ADDENDUM NO. 1

May 10, 2022

Silver Creek School District – Athletics Package and Steel & Roofing Package
Sellersburg, IN 47172

DRAWING TITLE:
ROOF FRAMING
PLAN - UNIT A

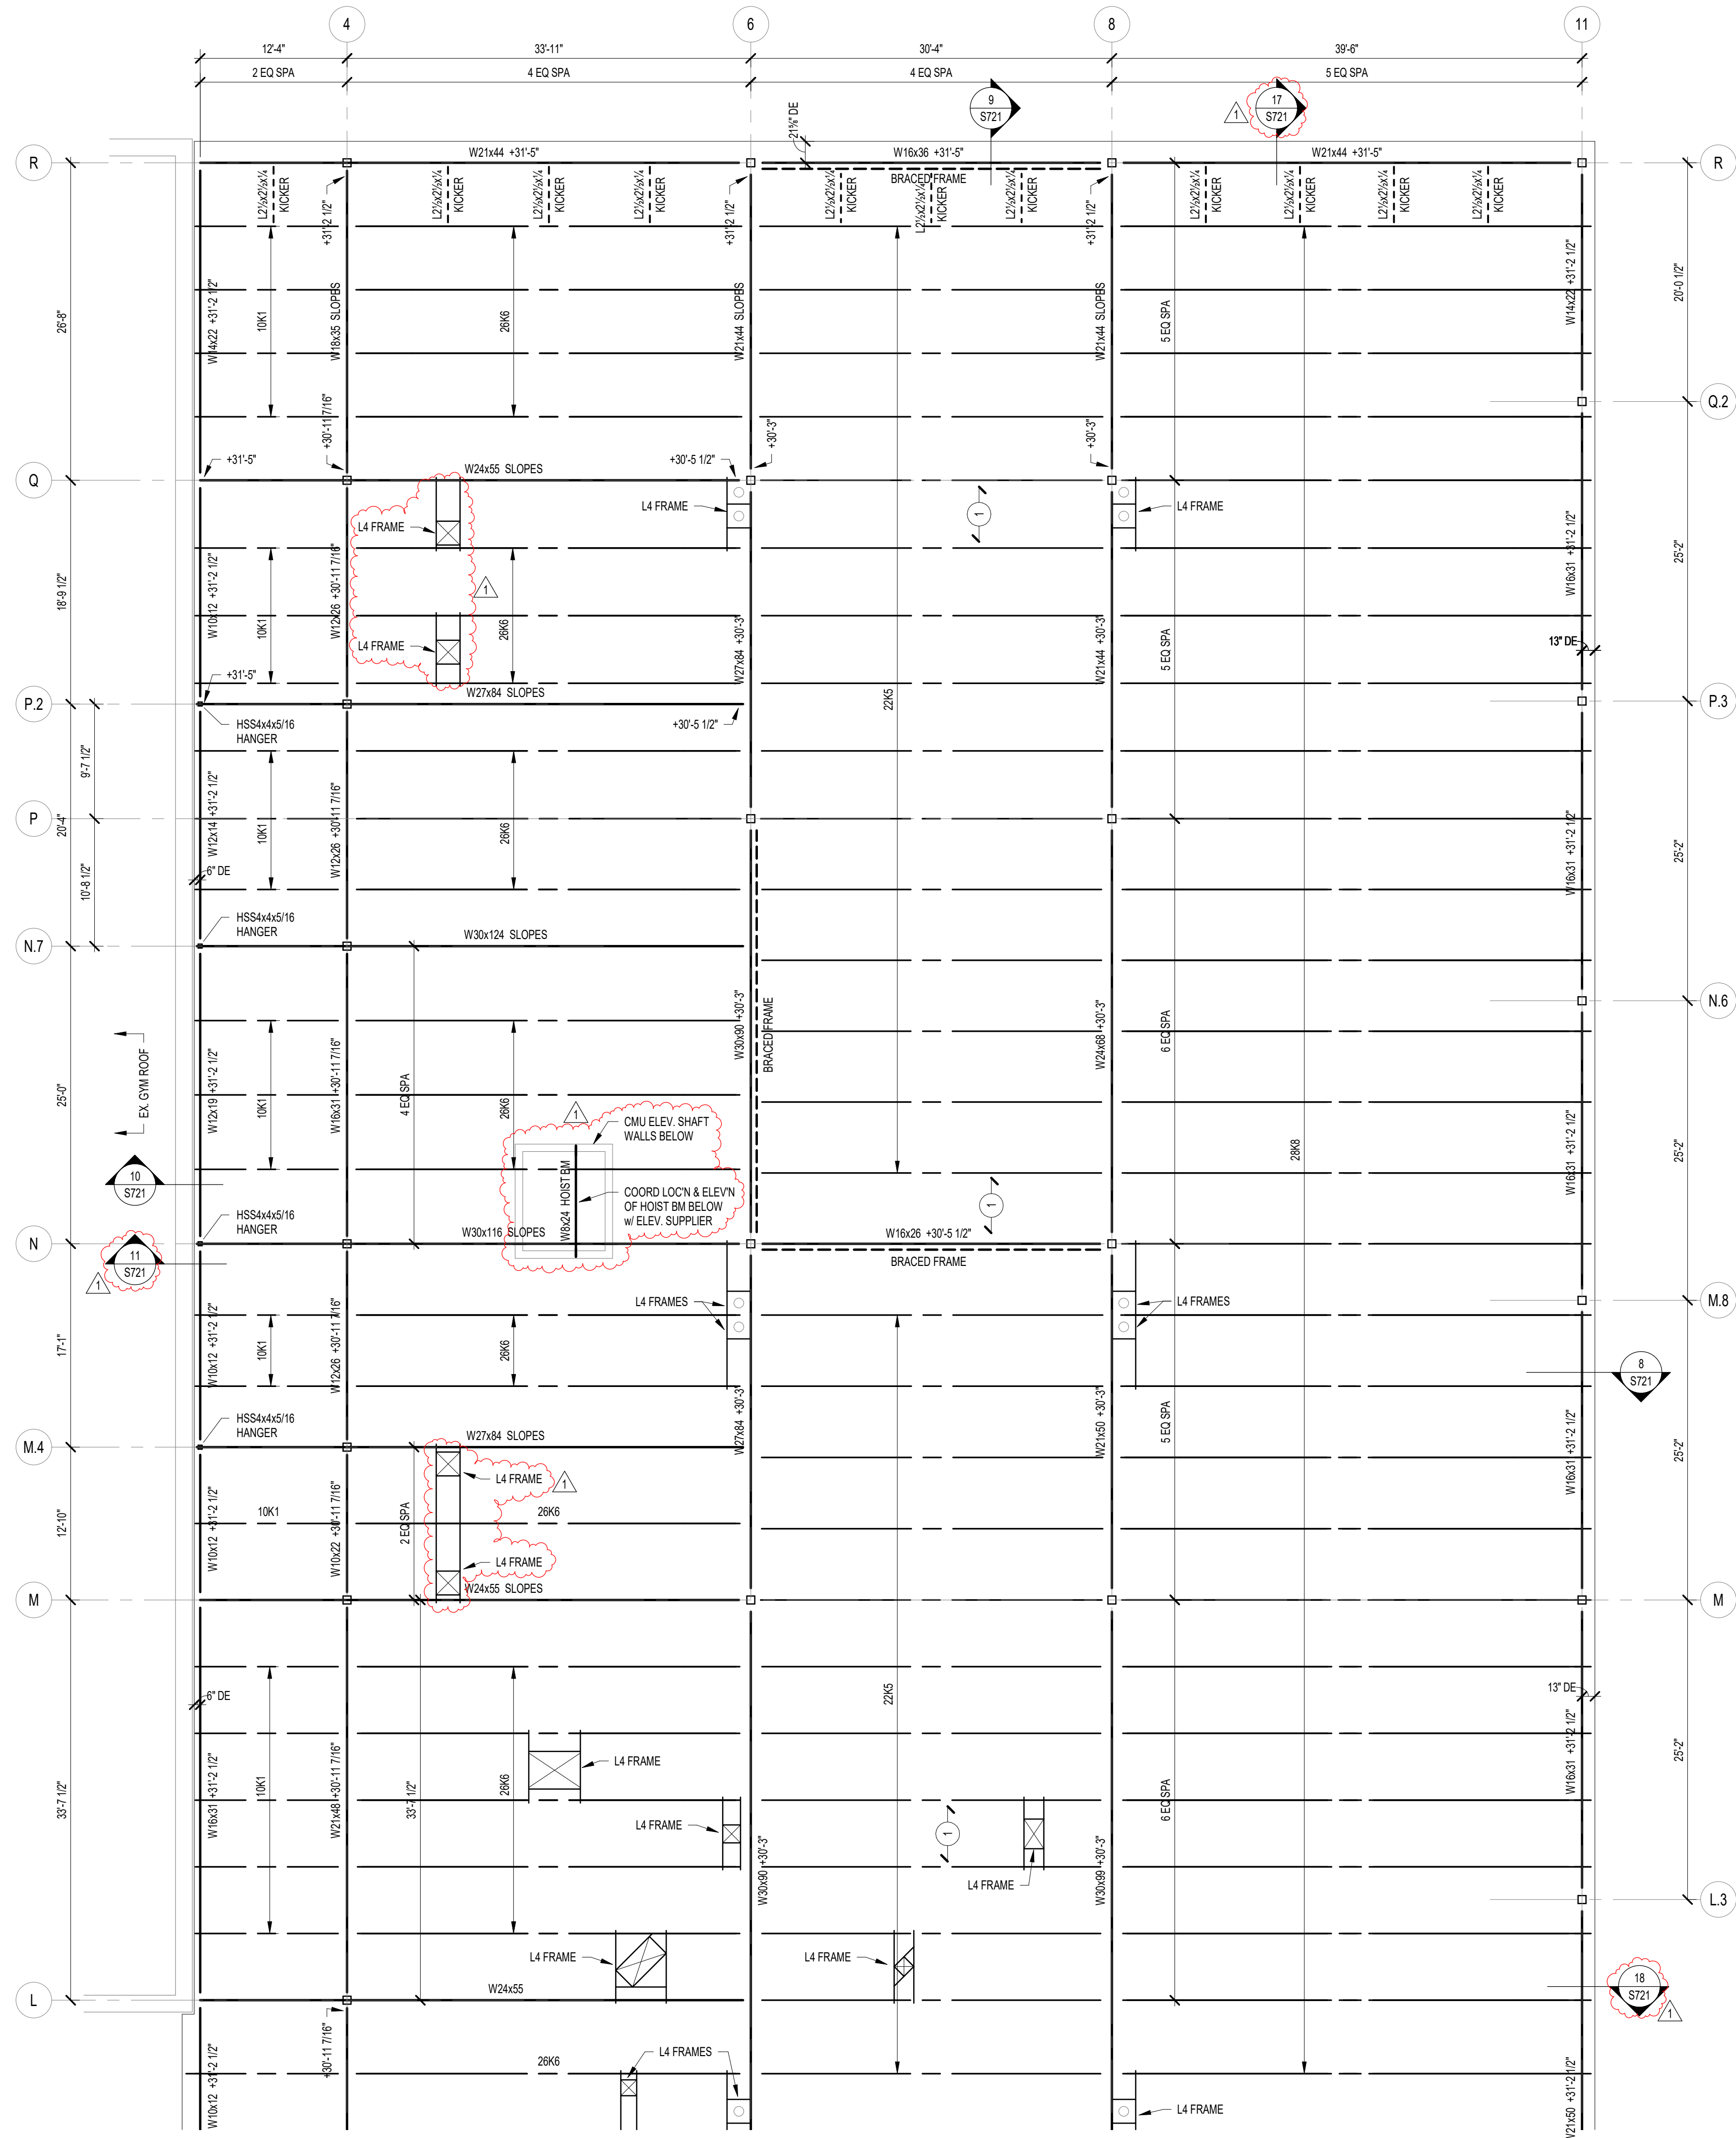
3.8 ☐ S203A – ROOF FRAMING PLAN – UNIT A

- ☐ Add section cut references as shown on attached revised sheet.

DRAWING TITLE:
ROOF FRAMING
PLAN - UNIT E

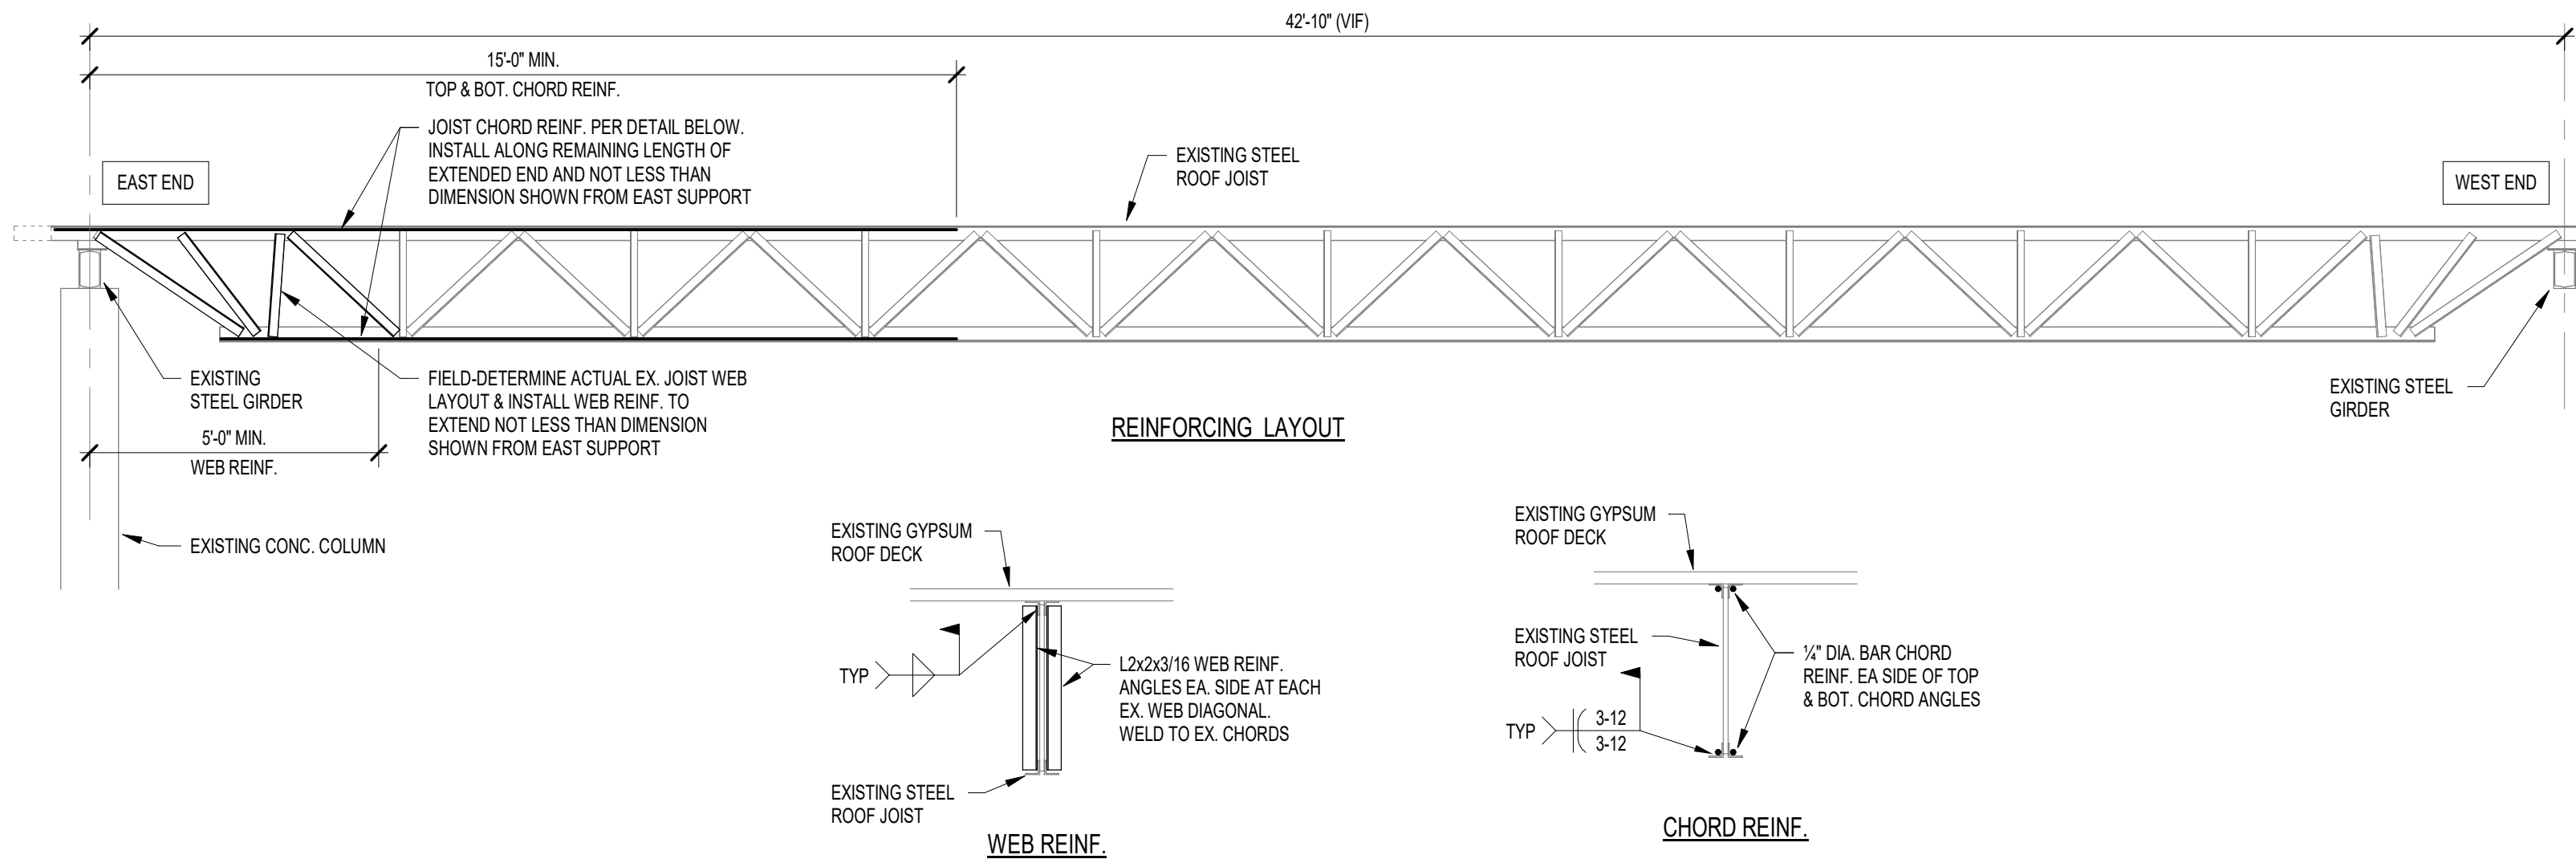
3.10 ☐ S203E – ROOF FRAMING PLAN – UNIT E

- ☐ Add section cut references as shown on attached revised sheet.
- ☐ Show elevator shaft walls below and add hoist beam callout and note as shown on attached revised sheet.
- ☐ Add L4x4x1/4 roof opening frames as shown on attached revised sheet.

DRAWING NUMBER
S711

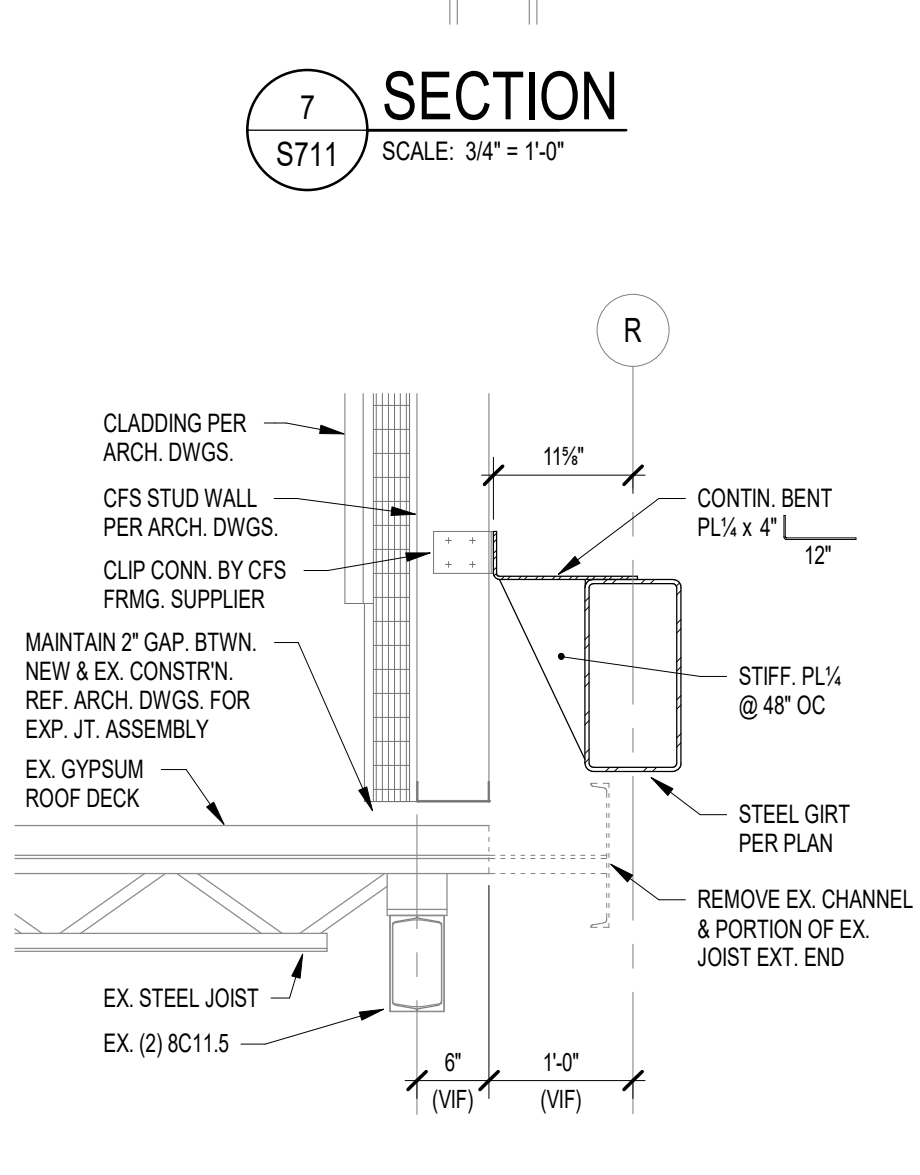
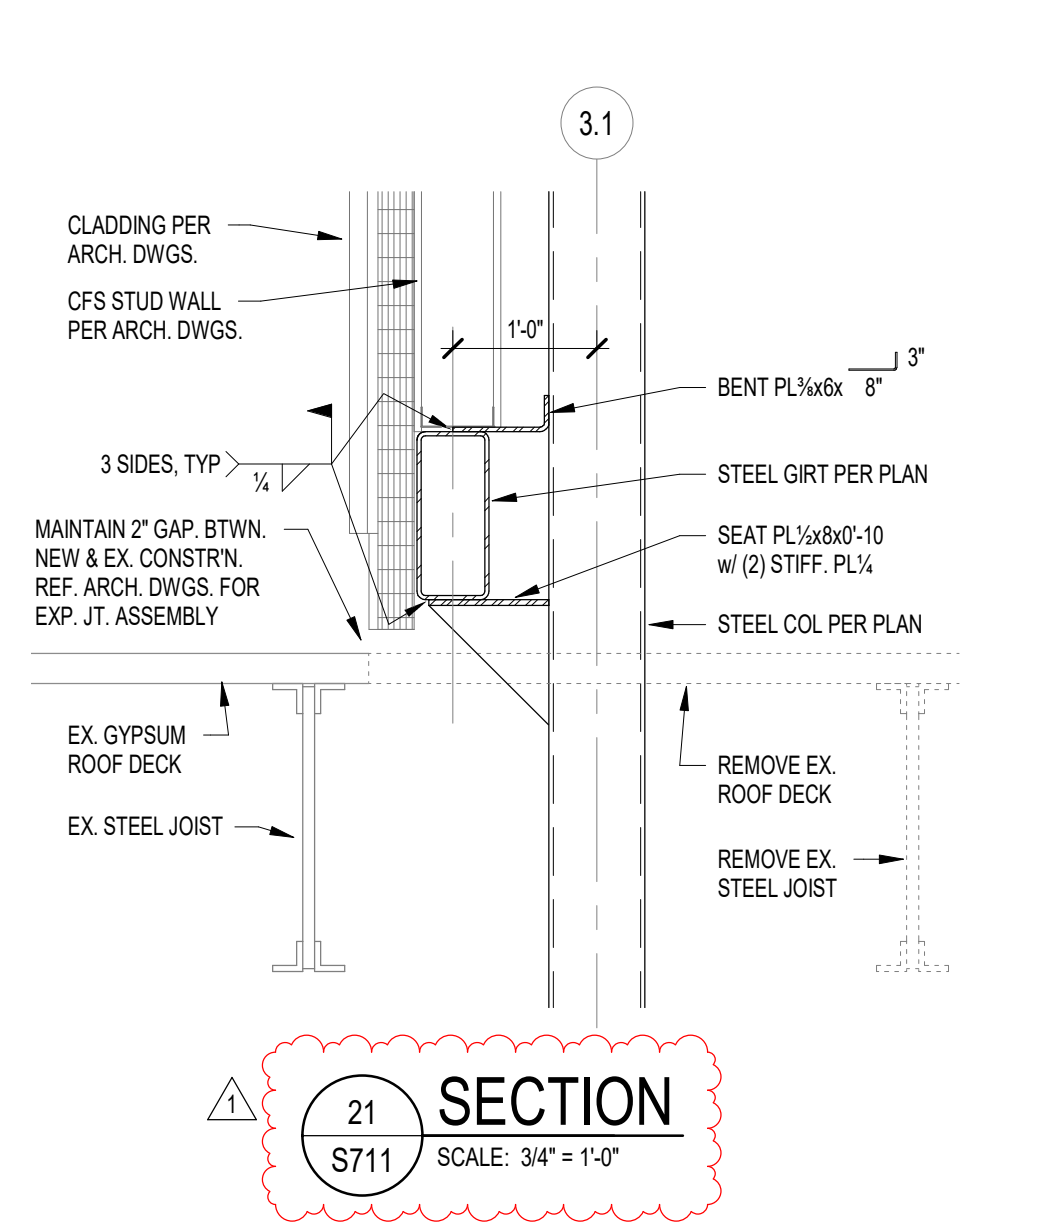
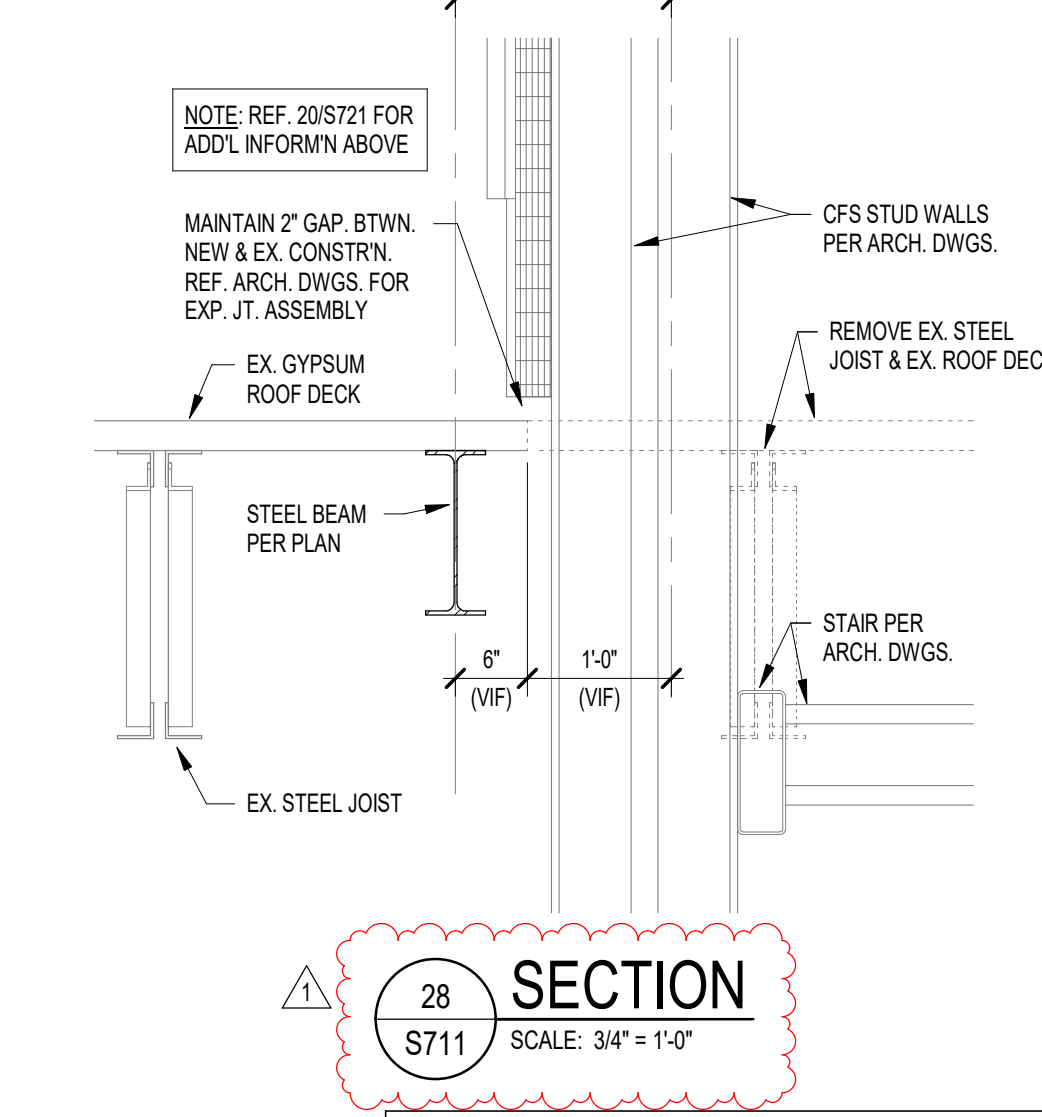
- ☐ Modify section 13/S711 to turn angle leg down as shown on attached revised sheet.
- ☐ Add sections 16 through 28/S711 as shown on attached revised sheet.
